ADDENDUM NO. 1

2021 21-315.1 RE-BID EAST BRANCH AUSABLE RIVER RESTORATION PROJECT

Town of Jay – Essex County, New York

June 4, 2021

TOE WOOD CONSTRUCTION SEQUENCE

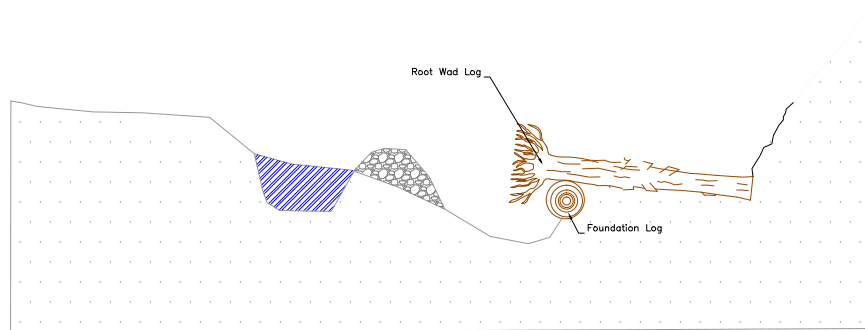
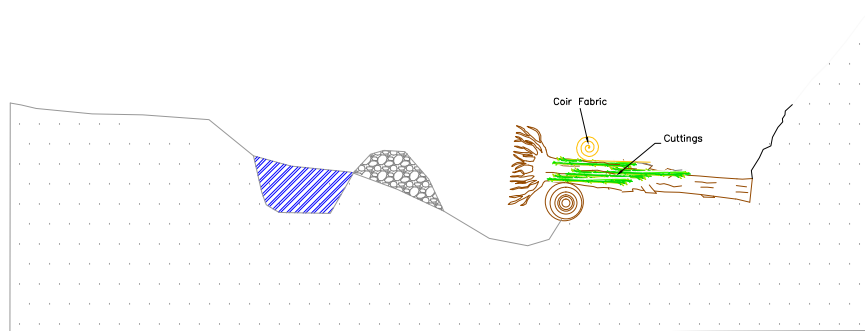
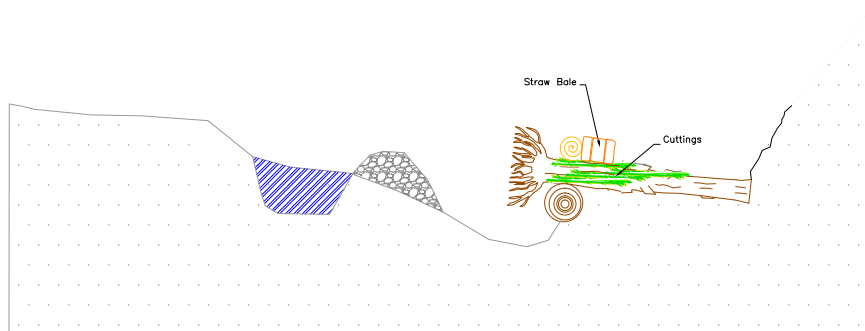
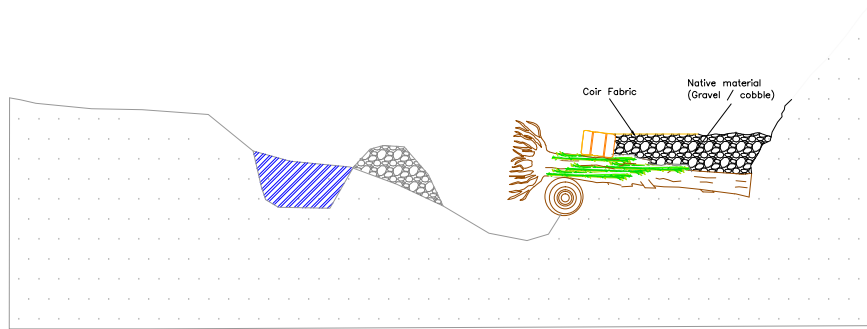
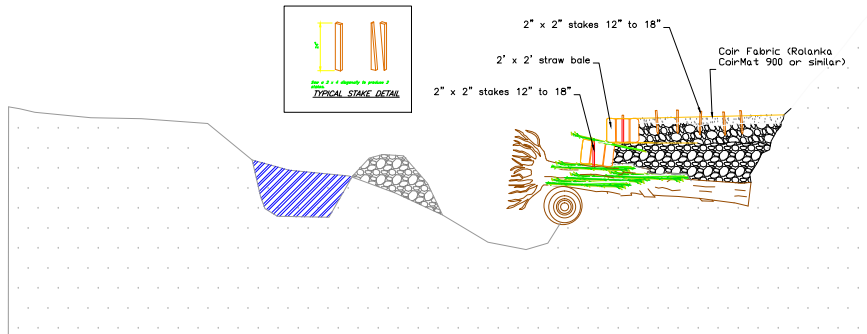
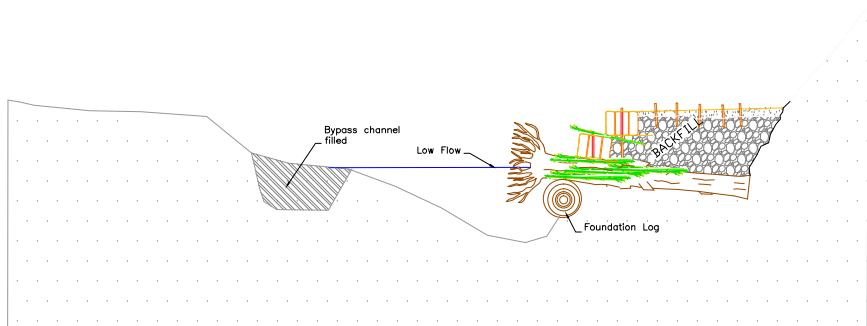
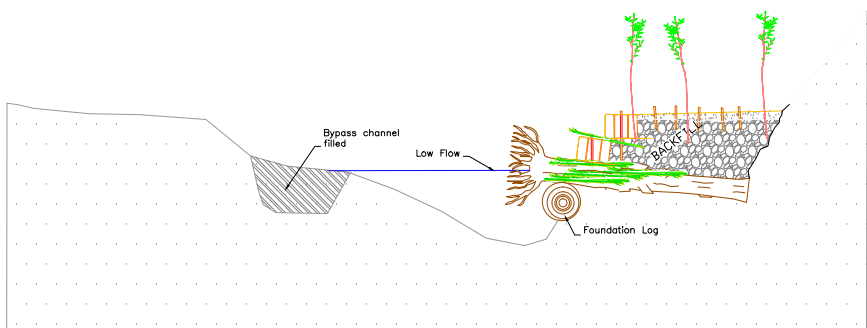
- As guidance for estimating the number of trees that will be required assume a frequency of one tree for every 15 lineal feet of toe wood bench.
 - See attached Toe Wood Construction Sequence Sheets and photographs from another similar scale toe wood project for additional information and guidance regarding toe wood bench construction. Please note that the projects in Jay do not involve straw hay bales.

DRAWING NO. SK2-4	SHT. <u>2</u> OF <u>2</u>
	REV. <u>2</u>

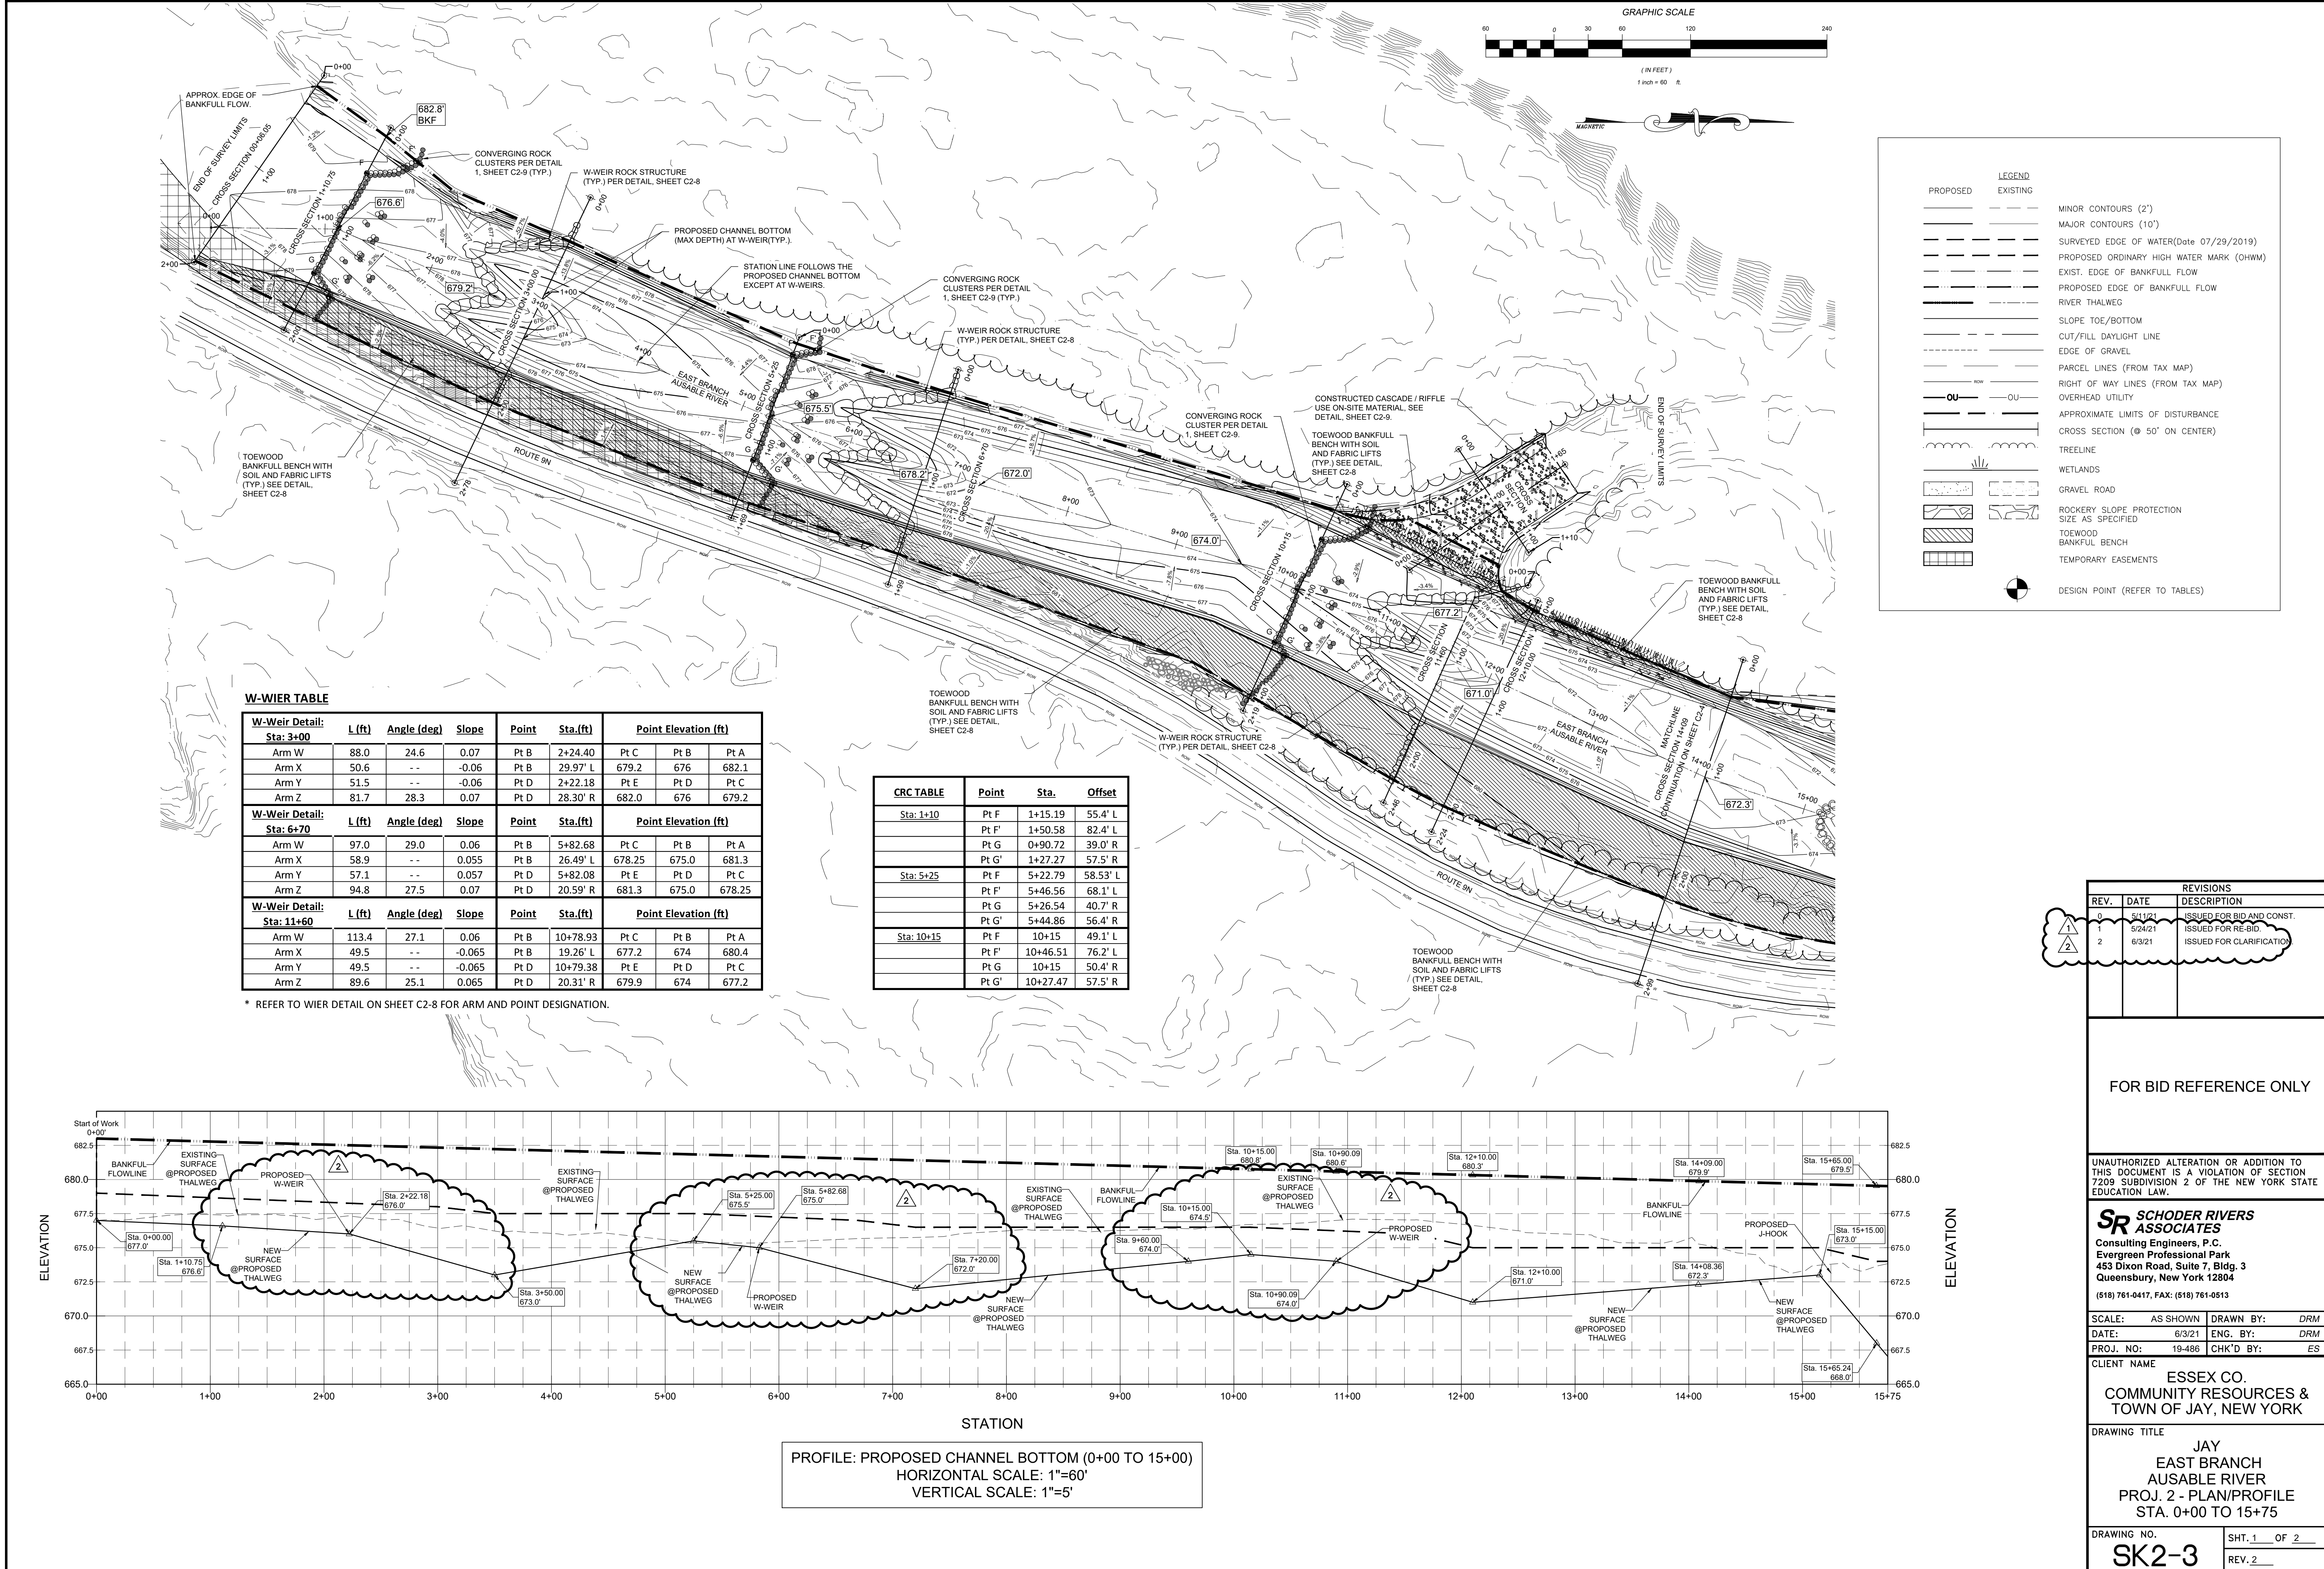
2. Additional plan sheets SK2-3, SK2-4, SK3-3, and SK3-4 have been issued and are attached. These sheets are supplementary to the site plan / profile sheets and show existing ground contours as well as proposed. In addition, the profiles have been corrected on these sheets to remove a superfluous line that appears above each weir on the plans that were issued with the re-bid.
